FIFTH & UNION | RAINIER SQUARE REDEVELOPMENT  
Early Design Guidance Submittal #2

PROJECT #3017644

July 25, 2014

This document has been prepared in response to the Early Design Guidance of the Downtown Design Review Board, as published in minutes of the meeting held on June 17, 2014. In that meeting, priority design guidelines were identified along with recommendations of the Board.

10' Setback and Curves in Base Help  
Retain Visibility of Rainier Tower

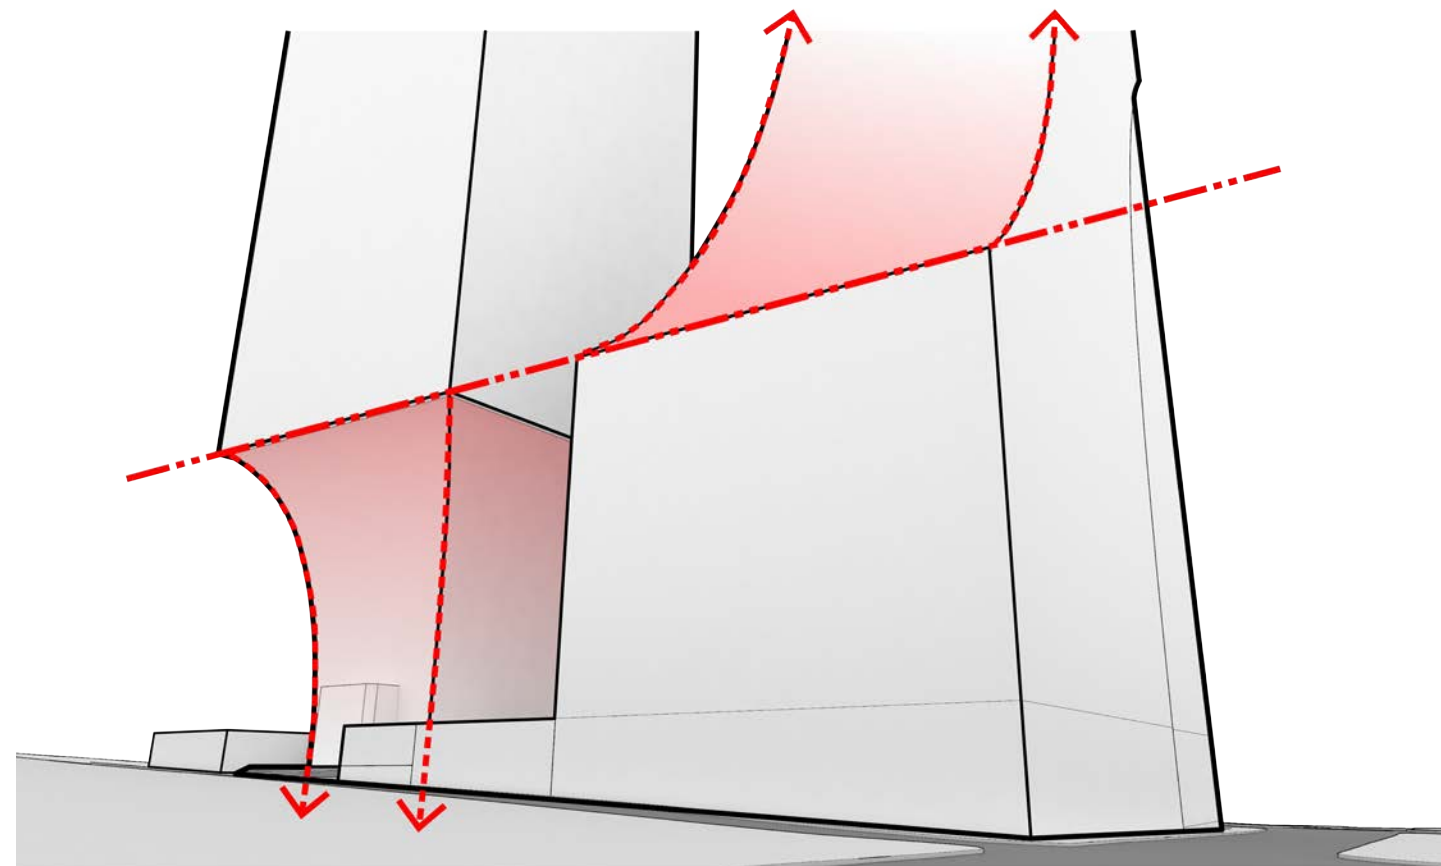
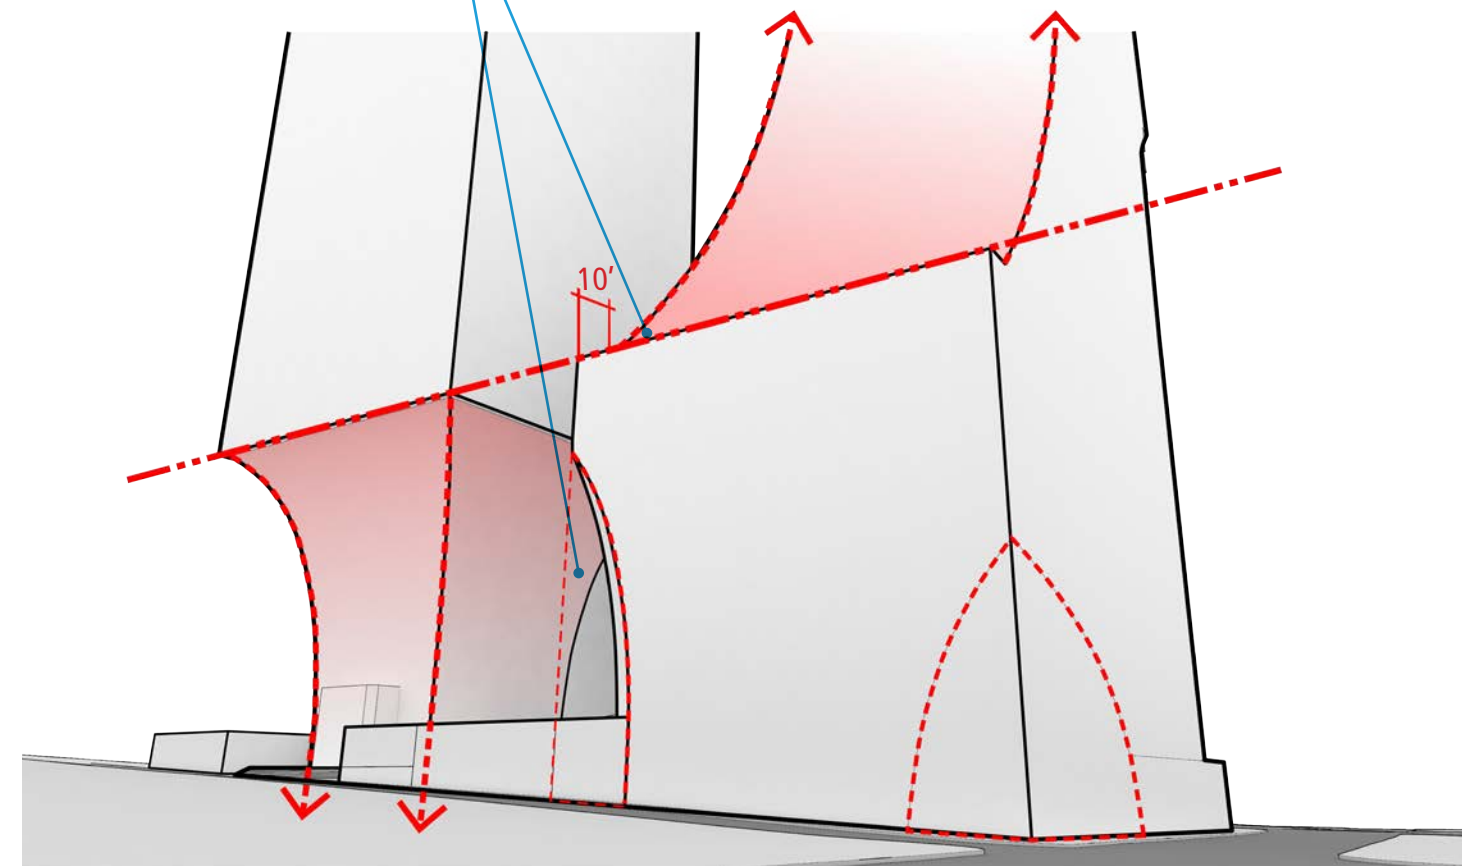
The concavity of Rainier Tower's base provides the design motif for the proposed tower's form. The architect's inversion of the form, a broad base tapering upward to the shaft, creates a visual reference. At the next meeting, the Board would benefit from a clearer understanding of the compelling reasons for the tiered or stepped building mass. Consider beginning the steps or tiers closer to the pedestrian level. The Board noted that this mid-section of the building has little or no engagement with the form that influenced it.

The design has been specifically modified at the pedestrian levels along Fifth Avenue by "carving away" some of the lower façade in a manner reminiscent of Rainier Tower's base, opening up views to the open spaces in the interior of the block as well as to the base of the existing tower. Furthermore, the beginning of the sloped section of the tower's midsection has been set back from the façade by approximately ten feet to reinforce the inverse and complementary relationship between the negative space of Rainier Tower base and the street wall of the new development along Fifth Avenue. This creates yet another opportunity for open space as part of the overall spatial composition at the lower levels of the development.

Shifted Hotel Location Away from University Street to Maximize Views at Pedestrian Level towards Rainier Tower

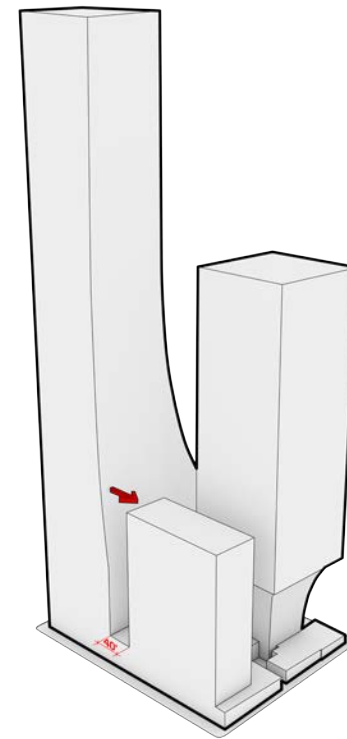
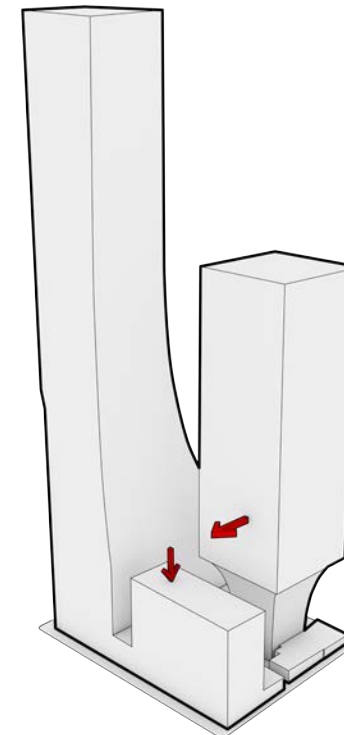
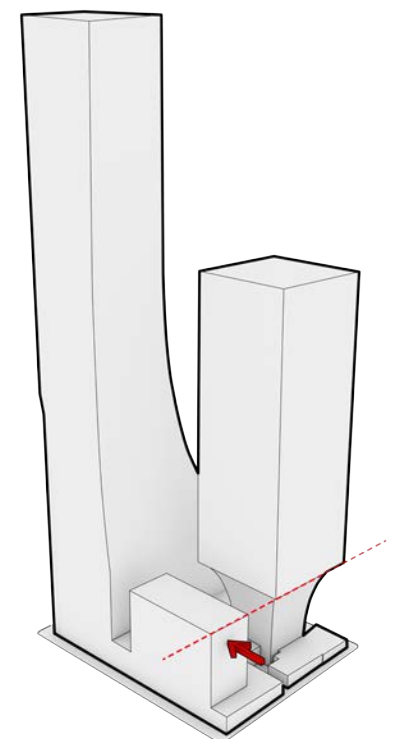
The Board observed that the hotel's massing and placement appears separate or detached from the rest of the complex. Further consideration should occur about 1) its location and its effect on view blockage of the base from the west and 2) the lack of visual synergy with Rainier Tower. The Board raised the prospects of a taller, narrower hotel structure or one embedded in the proposed tower similar in intention to the manner in which the residential volume expresses itself in Alternative # 2 as a singular form but within the larger building mass.

The placement of the hotel program and massing is an integral part of the concept for the site. The tower and the hotel are separated to achieve several important goals:

- Introduce additional light and air into the interior of the block, along with view angles to and from the interior from the surrounding streets and buildings along 4th Avenue. This results in additional usable open space and massing articulation at a lower level along the Fourth Avenue urban corridor.
- Provide an opportunity for the hotel to possess a distinct identity in the composition of the block - this is important to attract top-tier hotel operators.

It is important to note that the hotel is connected to the rest of the complex at the second level - this is an integral part of the programming strategy as well as providing connections to and from the open spaces for residents and users.

In response to the board's comments, the massing of the hotel has been shifted away from University Street in order to open up a wider view of the Rainier Tower base from the pedestrian realm. This improves the visual framing of the negative space formed by Rainier Tower's base, which is further defined and complemented by the massing and articulation of the proposed surrounding development.

View from North on Fifth Avenue

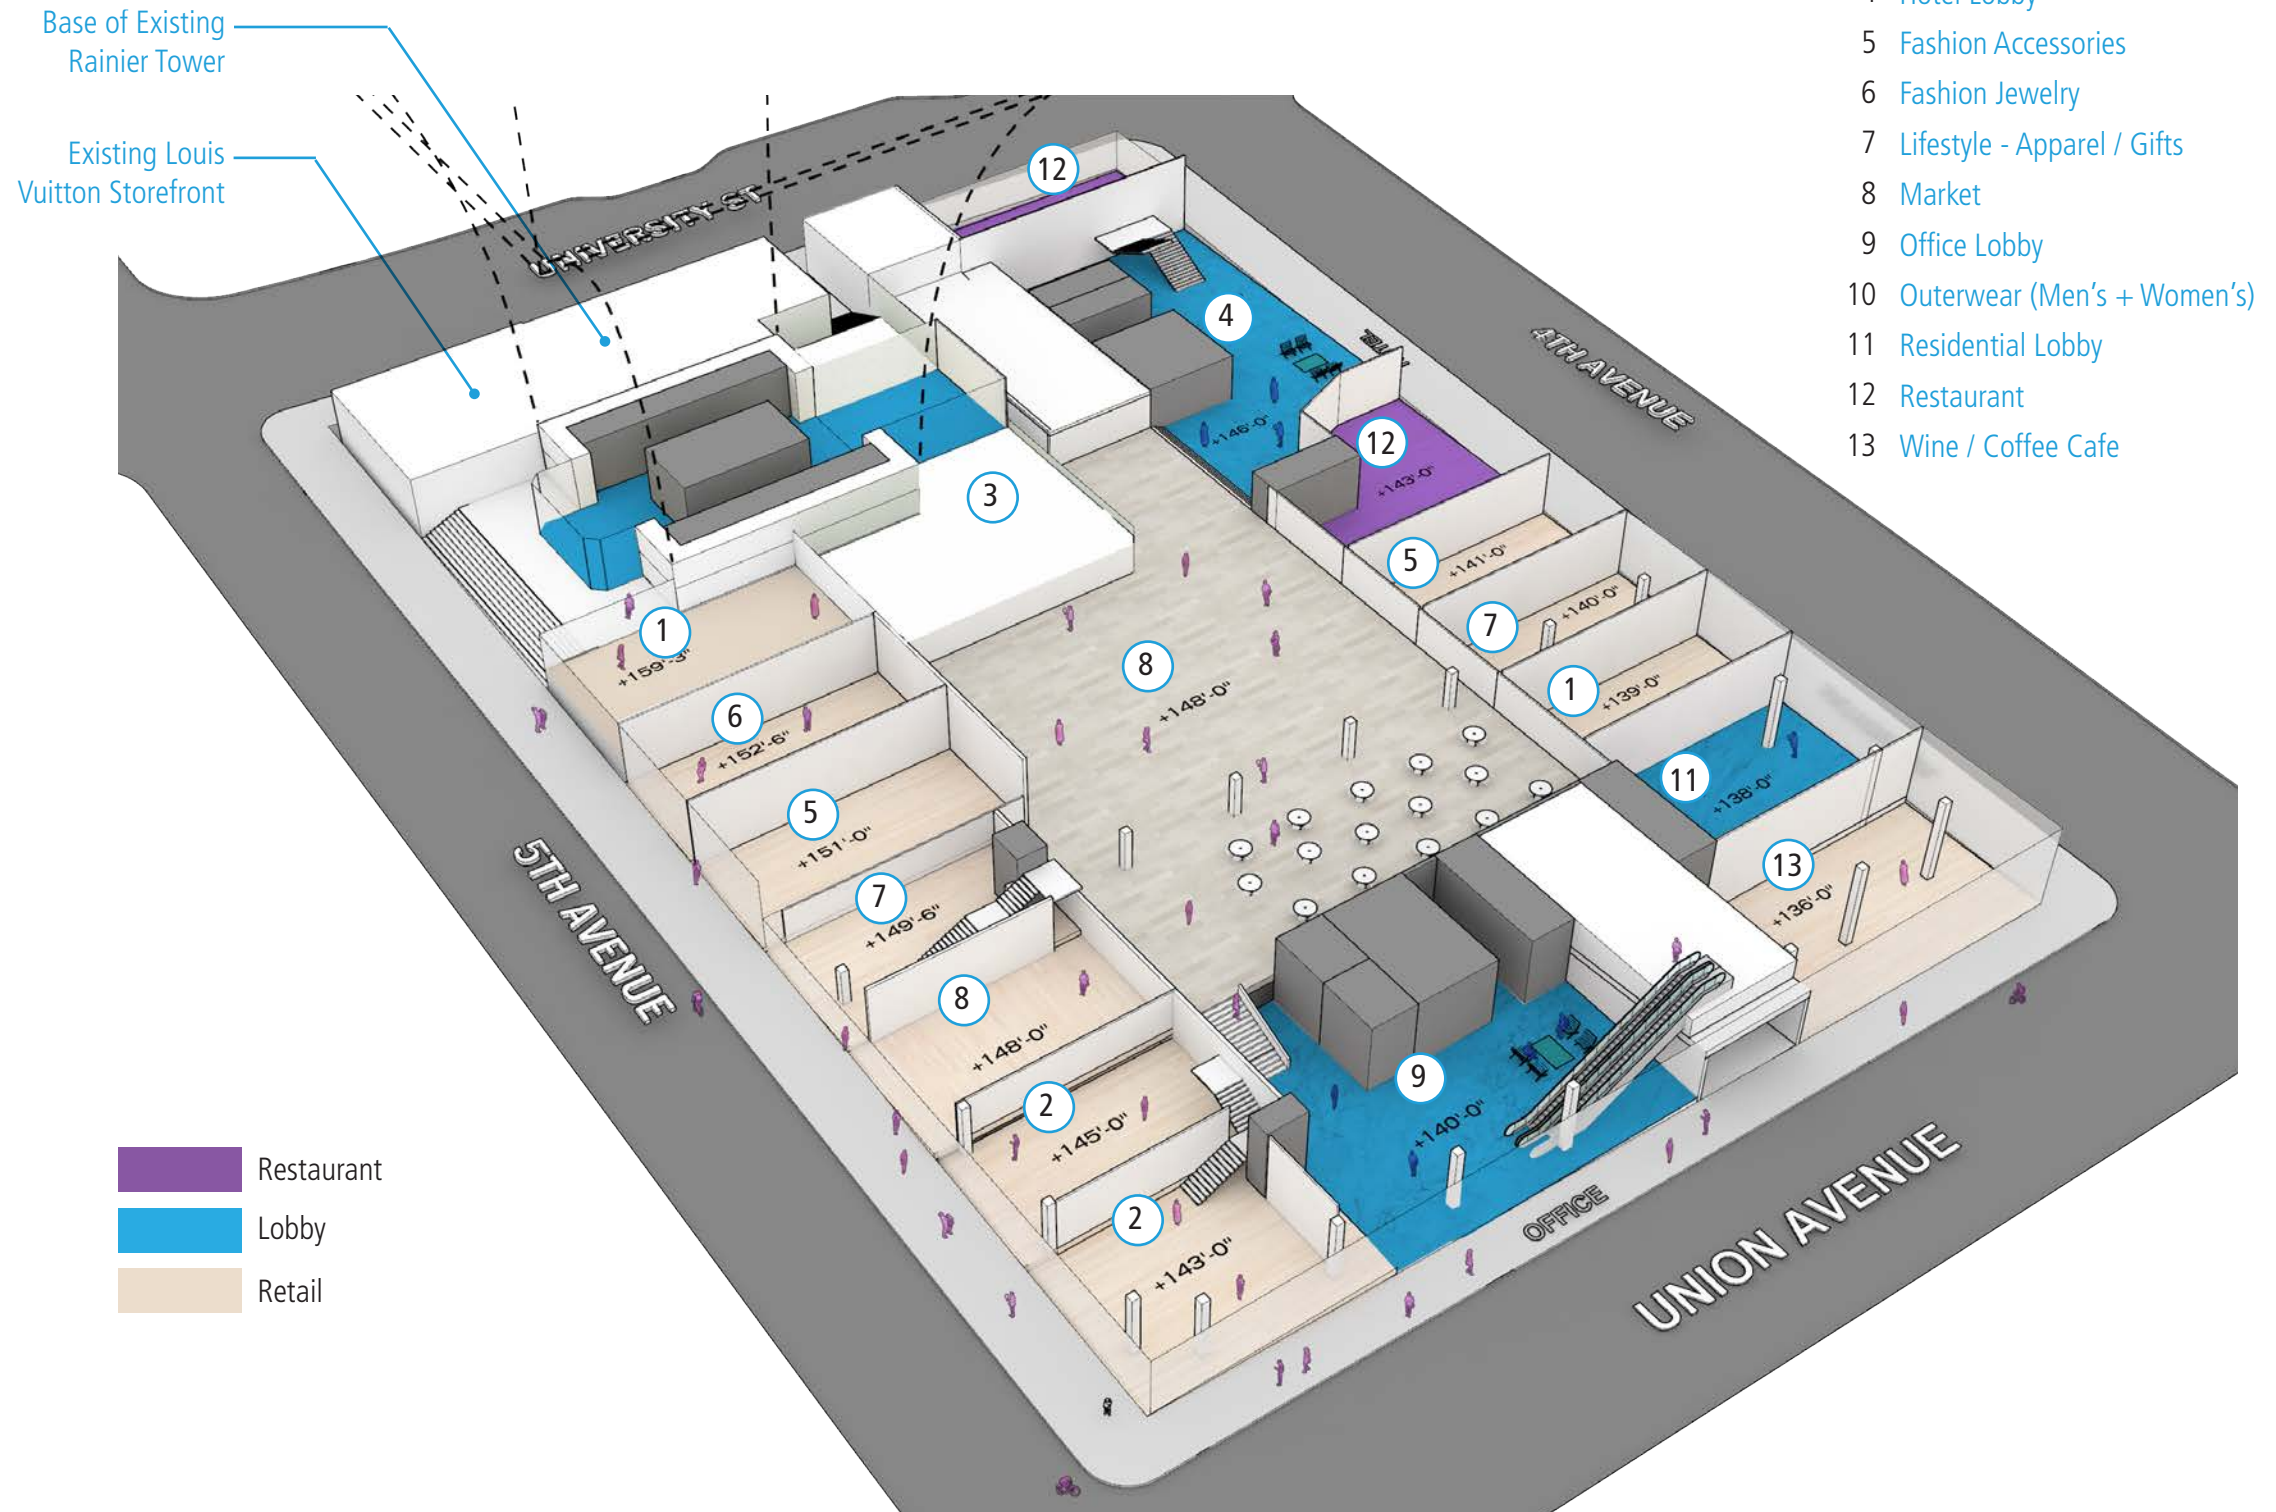
In following meetings, the architect should provide perspectives of the streetscapes that include the massing of Rainier Tower and the proposed towers. As the design for the commercial plinth evolves more information should inform the reader of the retail components.

The base of the project is envisioned as a lively mix of vibrant, pedestrian-oriented retail and hospitality uses. A central concept is that of a "market" or "hub" space in the interior of the block, with a large glass ceiling to introduce natural light and visual connection to Rainier Tower and the rest of the development. Along the street frontages, a carefully curated mix of retail, restaurants, coffee shops, and elegant lobby spaces will engage the interest of pedestrians with multiple and varied storefronts, open facades, lighting, merchandising displays, areas for seating, and other activities that will spill out onto the sidewalk to promote friendly interaction. A refined palette of materials and detailing will enhance the quality of the street-level experience.
